Southern Nuclear Operating Company
October 12, 1993 *the southern electric system*

Docket Nos. 50-348
50-364

Joseph M. Farley Nuclear Plant
Response to Request for Additional
Information Concerning NUREG-0737 Item II.D.1

Figure 1

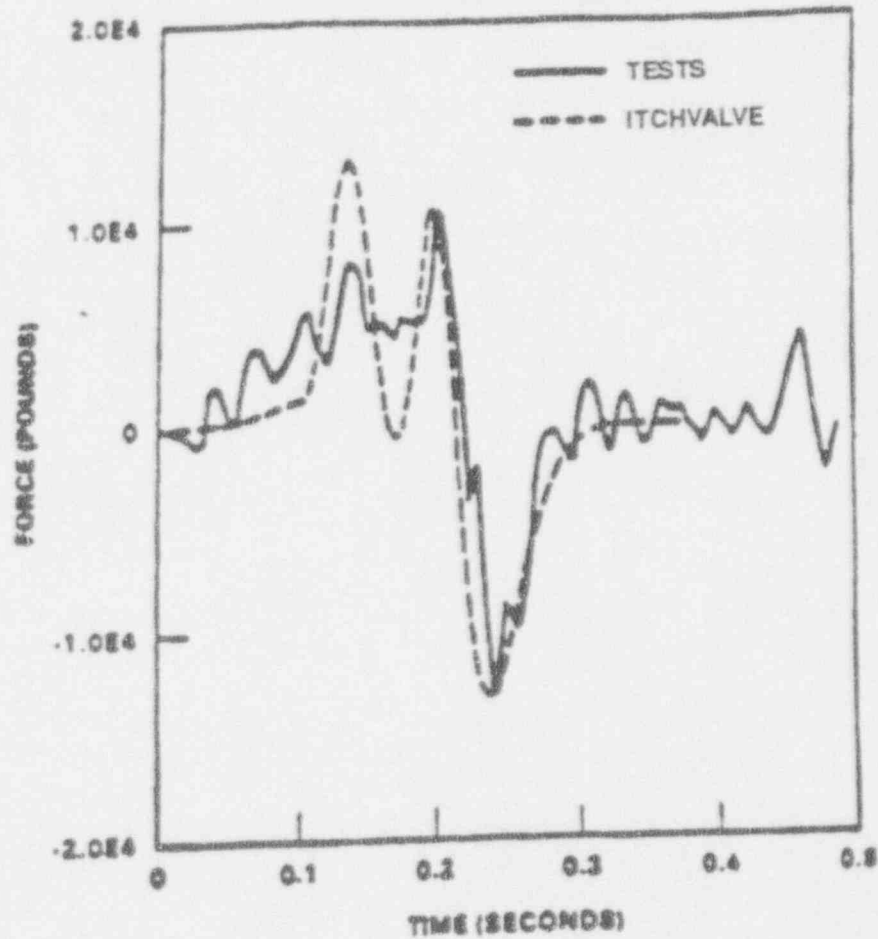
The August 7, 1992, submittal, identifies that the computer program ITCHVENT was used for the thermal hydraulic analysis. Since the submittal describes this program as an updated version of the program ITCHVALVE, which had been previously benchmarked against the EPRI test data, describe any changes incorporated in ITCHVENT which could impact the original benchmarking process.

Program ITCHVENT/ITCHVALVE, which generates thermal hydraulic forcing functions, was benchmarked to the EPRI test results for test 908 (cold loop seal) and test 917 (hot loop seal). Attached in Figures 1 and 2 are comparisons of the EPRI test results with the thermal hydraulic analysis results performed by ITCHVALVE. The analysis results generated by ITCHVENT were also compared to the ITCHVALVE and EPRI results and were found to envelope the ITCHVALVE results. Figures 3 and 4 also demonstrate the shapes of the forcing functions are very similar.
